Access Compliance Report

Public Rights-of-Way

(Curb Ramps)

Intersection ID: 10026082	Main Street: ENDAHVEN_LN	Cross Street: N/A	Location: SW
ADA ID: 777ED0F69990	Ramp Type: Perp	Initial Pass/Fail: Fail	Overall Compliance: No
Severity Score: 13.75			
Codes/Mitigation Info/Possible Solution		Field Measurements/Component Compliance

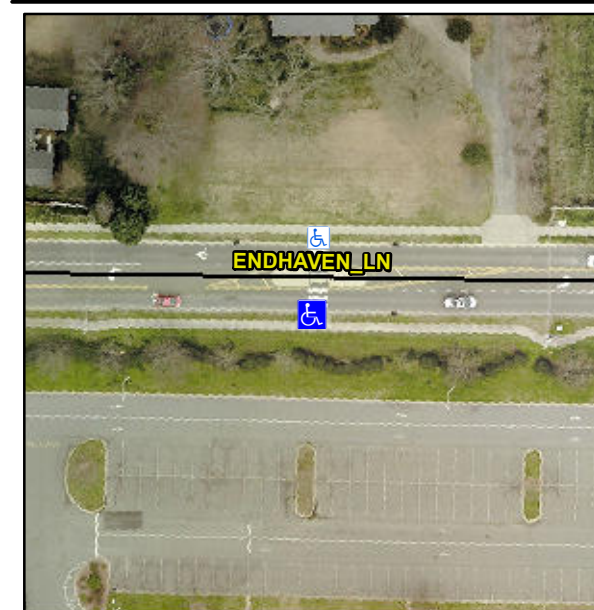
Not Found, R304.2.2, R304.5.3

Compliance	Description	Data	Compliance	Description	Data
N/A	Ramp Length (in)	101.0	No	Ramp Slope (%)	8.6
Yes	Ramp Width (in)	48.0	No	Ramp XSlope (%)	2.3
N/A	Flare Type LT	N/A	N/A	Flare Type RT	N/A
N/A	Flare Slope LT (%)	N/A	N/A	Flare Slope RT (%)	N/A
N/A	Flare Traversable LT?	N/A	N/A	Flare Traversable RT?	N/A
N/A	Landing Length (in)	N/A	N/A	DWS Provided?	N/A
N/A	Landing Width (in)	N/A	N/A	DWS Contrast?	N/A
N/A	Landing Slope (%)	N/A	N/A	DWS Length (in)	N/A
N/A	Landing X Slope (%)	N/A	N/A	DWS Full Width?	N/A
N/A	Landing Curb? (Y/N)	N/A	N/A	DWS Offset (in)	N/A
N/A	Shared Landing?	N/A			
N/A	Gutter Ponding?	N/A	N/A	Gutter Slope (%)	N/A
N/A	Gutter Lip Ht (in)	N/A	N/A	Gutter X Slope (%)	N/A
N/A	Painted X Walk1?	Yes	N/A	Painted X Walk2?	N/A
	X Walk 1 Direction	To NE		X Walk 2 Direction	N/A
N/A	X Walk 1 Width (in)	128.0	N/A	X Walk 2 Width (in)	N/A
	X Walk 1 Slope (%)	2.8		X Walk 2 Slope (%)	N/A
	X Walk 1 X Slope (%)	0.7		X Walk 2 X Slope (%)	N/A

N/A	Ramp inside XWalk1?	Yes	N/A	Ramp inside XWalk2?	N/A
	Road Slope (%)	N/A	N/A	Clear Space?	N/A
	Road X Slope (%)	N/A	N/A	Clear Space to XWalk (in)	N/A
N/A	Any Obstructions?	N/A	N/A	Storm Grate/Utility Hazard?	N/A
	Obstruction Type			Storm Grate/Utility Type	
		N/A			N/A
		Yes		Surface Condition? (G/P)	Good

Remove & Replace Entire Ramp.
